RECEIPT DATE: 11/2/16      **ONSITE SEWAGE DISPOSAL SYSTEM**      P 559828  
 APPROVAL DATE: 12/15/16 **PERMIT:**      **CONSTRUCTION**      A \_\_\_\_\_  
 PROPERTY ADDRESS: 3109 Longfield Road  
 SUBDIVISION: Wellington      LOT: 24      TAX ID: 05 598687  
 CONTRACTOR: South Carroll Backhoe      EMAIL: scbackhoe@comcast.net  
 CONTRACTOR ADDRESS: 4410 Salem Bottom Road      PHONE: 410-596-3618

**From:** Freemon, Robert [<mailto:rfreemon@howardcountymd.gov>]  
**Sent:** Wednesday, March 16, 2016 8:37 AM  
**To:** [jcarney@bei-civilengineering.com](mailto:jcarney@bei-civilengineering.com)  
**Subject:** 3109 Longfield Rd.

| LOCATION:<br>3109 LONGFIELD ROAD<br>GLENWOOD, MD 21738<br>TAX MAP No. 14 - GRID 21 - PARCEL No. 239<br>4TH ELECTION DISTRICT, HOWARD COUNTY, MARYLAND<br>TAX ID NUMBER: 14-349717 | TITLE:<br>BAT SITE PLAN   |

PLAN VIEW  
 1" = 30'

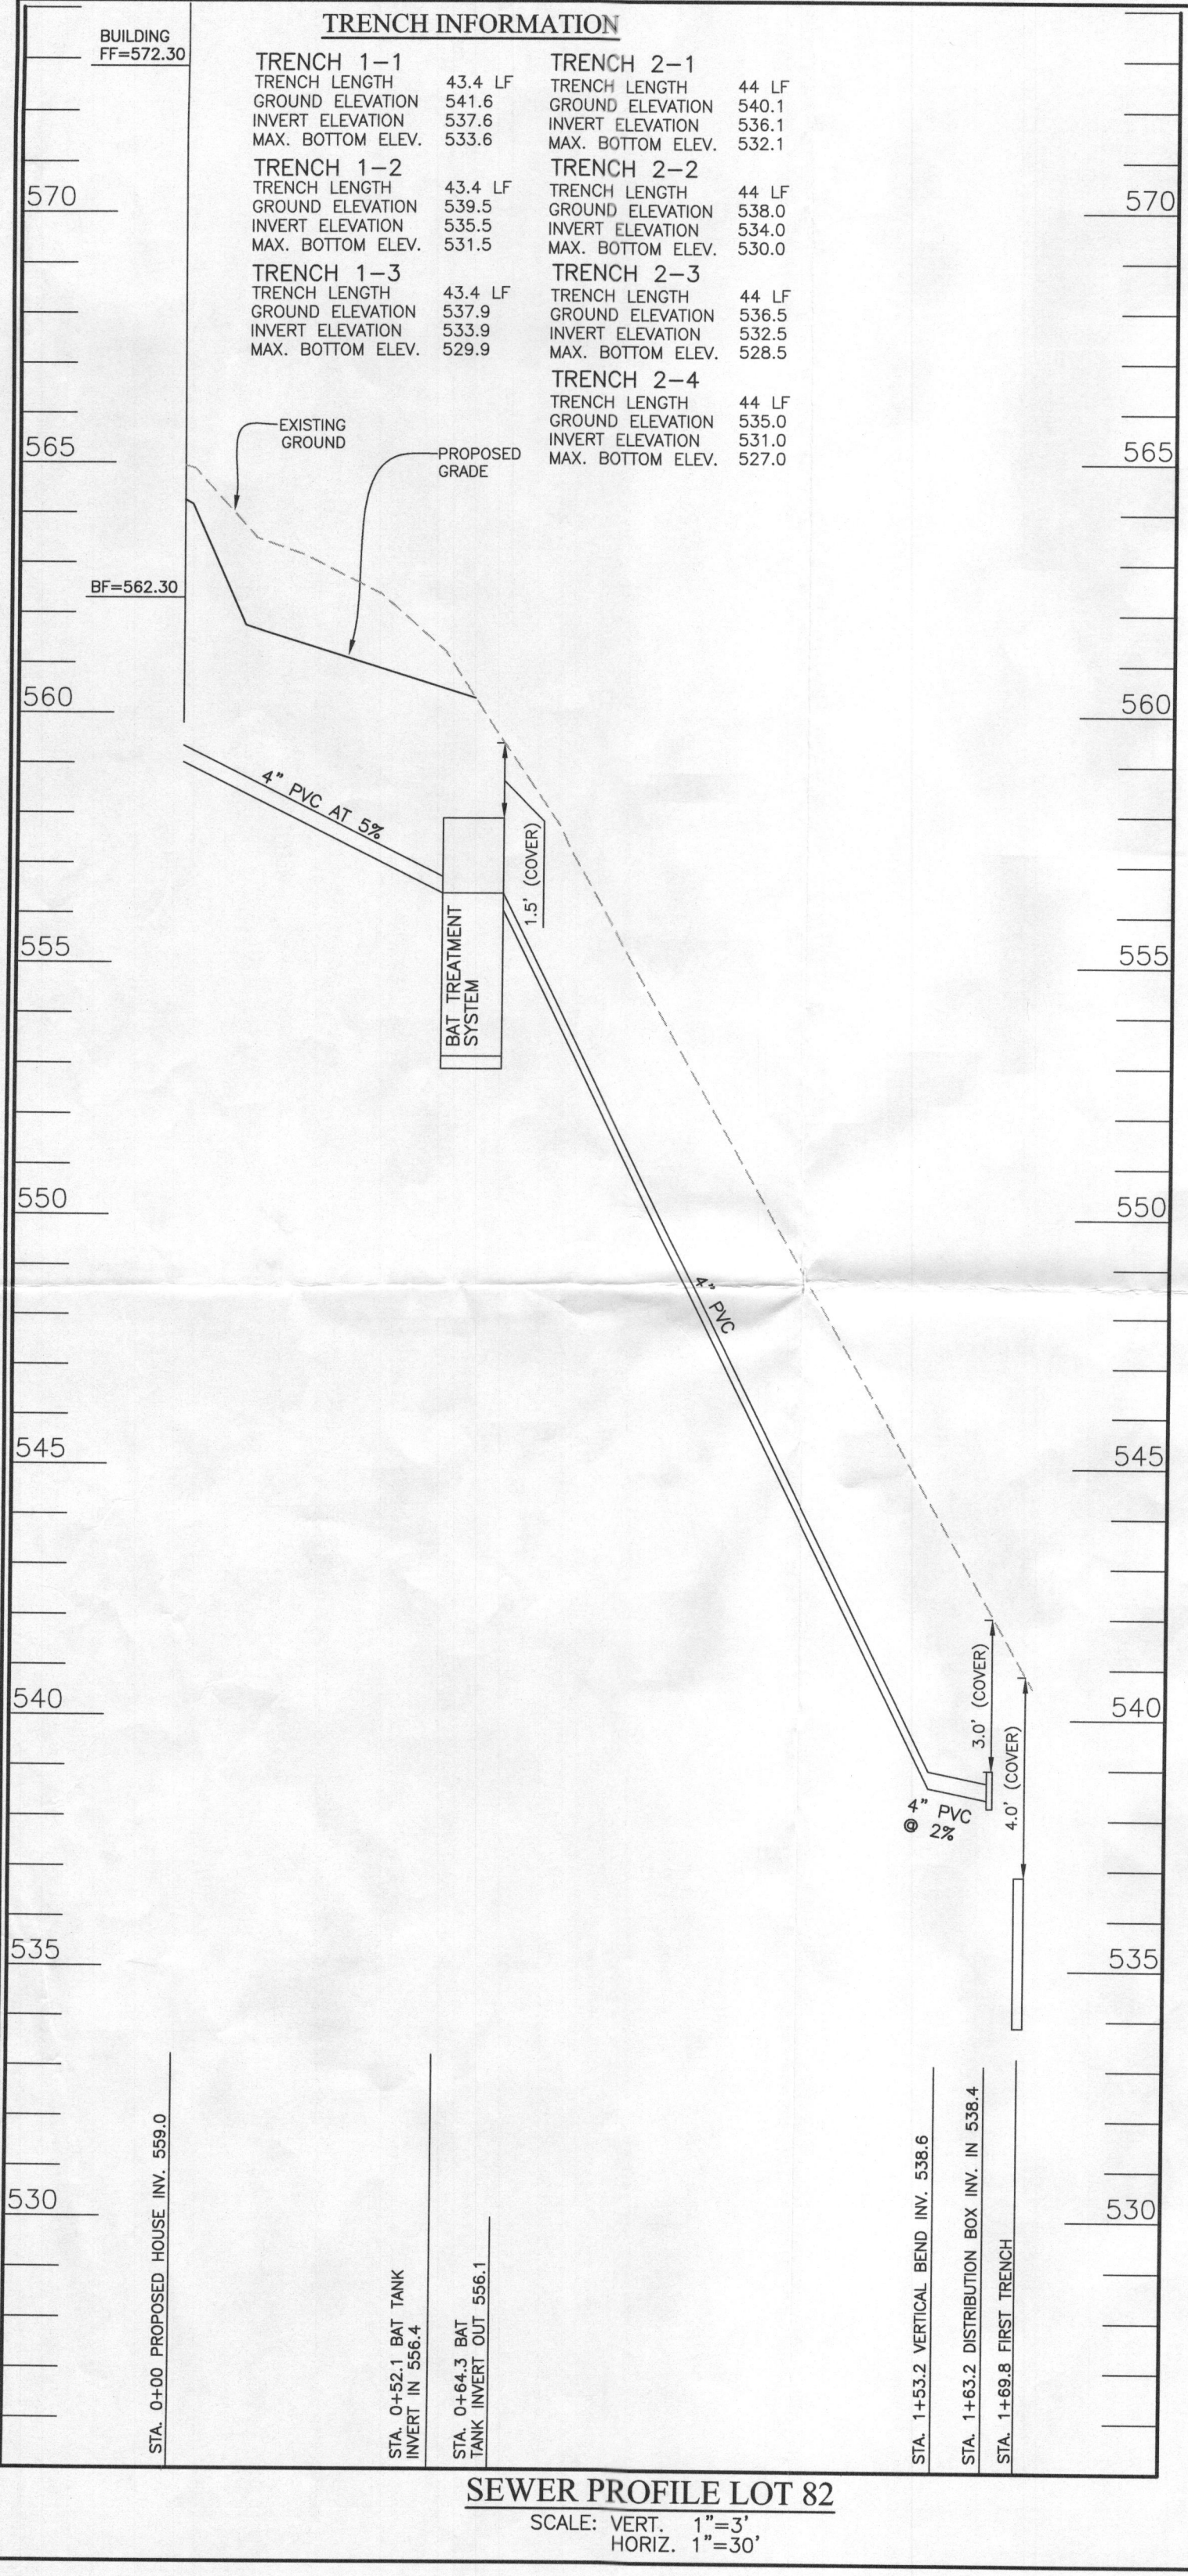
I have reviewed BP16000706 for 3109 Longfield Rd. and have some comments. Before we can approve the Building Permit a Well needs to be drilled and approved by the Health Dept. To obtain a Well Permit a surveyor needs to stake the proposed Well Box as well as fill out a stake form and have it submitted to the Health Dept. Additionally, BAT Plan will need to be submitted to the Health Dept. along with a Floor Plans.

Comments concerning the plot plan include Drywell 1 (DW-1) needs to be 100<sup>ft</sup> from the well box. I have attached the Spec Sheet and a link to the BAT plan checklist for your reference.

Robert, apparently the builder has submitted the preliminary house siting as a building permit plan. Normally the building permit plan would be submitted and would contain more information, notes, details etc. Additionally we'd also submit the BAT plan and architectural at that point. I've let the owner know that they are out of sequence. You will see a building permit plan soon that contains all the information that is normally required. Also we'll submit the BAT plan and architectural plans, directly to Health, around the same time. Thanks for the spec sheet. John
